Sallins Park  
Stage 2 Road Safety Audit

September 2021

## Stage 2 Road Safety Audit

Figure 2.2 – Direct Access Points onto Sallins Link Road

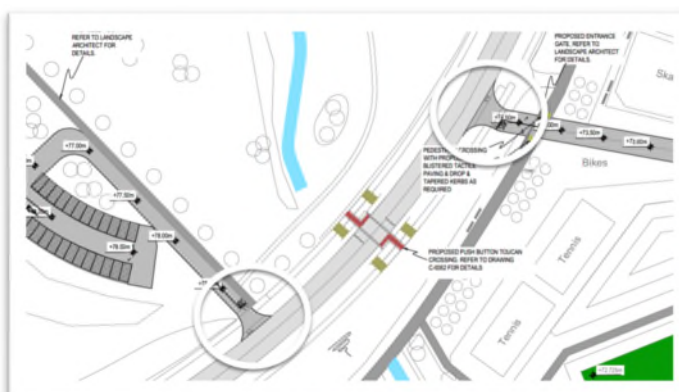
**Location:** Direct Access Points onto Sallins Link Road

Failing to afford advantage to pedestrians and cyclists on the link road could lead to conflicts with vehicles emerging from the Park.

The access points should be treated as ‘cross-overs’, whereby the pedestrian and cycling facilities on the Link Road continue uninterrupted through the access points. Emerging vehicles would then give way at the access points before crossing over the walking and cycling facilities with caution.

**Figure 2.3 – Car Park Aisle Cul d Sacs**

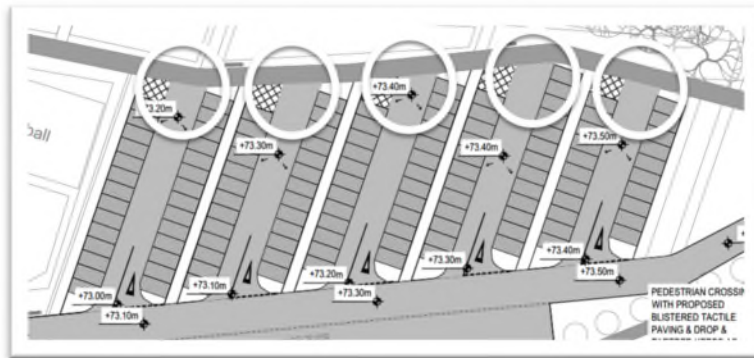
**Location:** Car Park

Creating a series of cul de sacs will result in countless reversing manoeuvres over the parks' operational lifecycle; particularly with vehicles hunting for a space when the car park is nearing capacity. The reversing manoeuvres will be undertaken adjacent to a main pedestrian route, placing vulnerable road users at risk of conflict.

The need for vehicles to reverse near the pedestrian route should be mitigated by making provision for them to orbit around the parking aisles whilst hunting for a space.

**Figure 2.4 – Crossing Near Sports Hall**

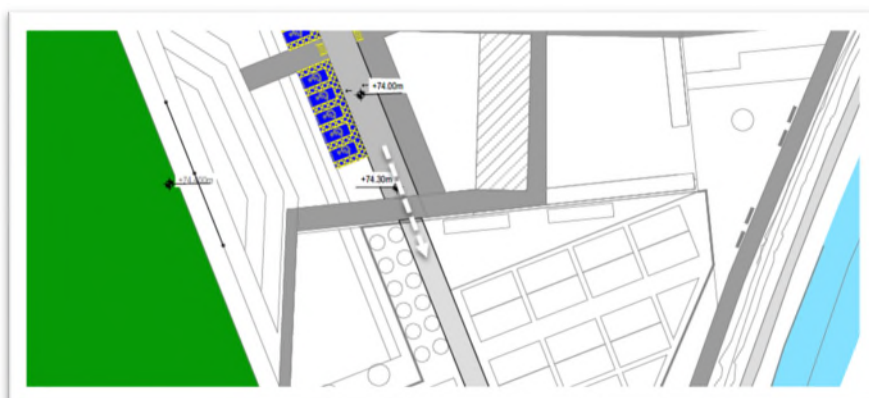
**Location:** Crossing Near Sports Hall / Disabled Parking

The internal road will narrow abruptly at a point where pedestrians will be encouraged to cross. This could lead to opposition type conflicts.

Measures to afford advantage to pedestrians should be provided here, along with an appropriate and consistent carriageway width.

**Figure 2.5 – Crossing Near Playground**

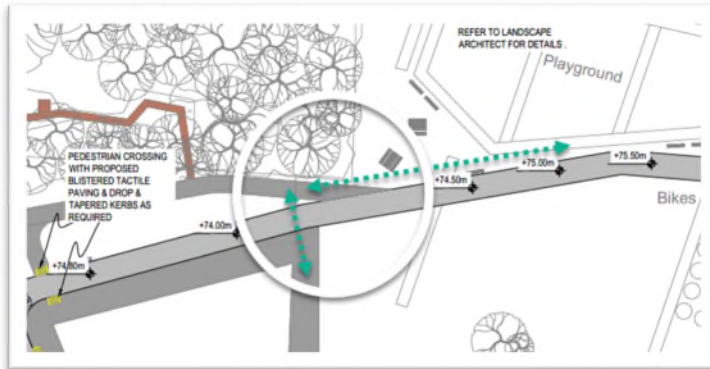
**Location:** Near Playground

The footpath will terminate at an acute angle, which could lead to pedestrians stepping into the carriageway with their backs to approaching traffic.

Extend the footpath to serve the playground and / or adjust it to address the road in a perpendicular manner and create a courtesy crossing to link with the path on the opposite side of the road.
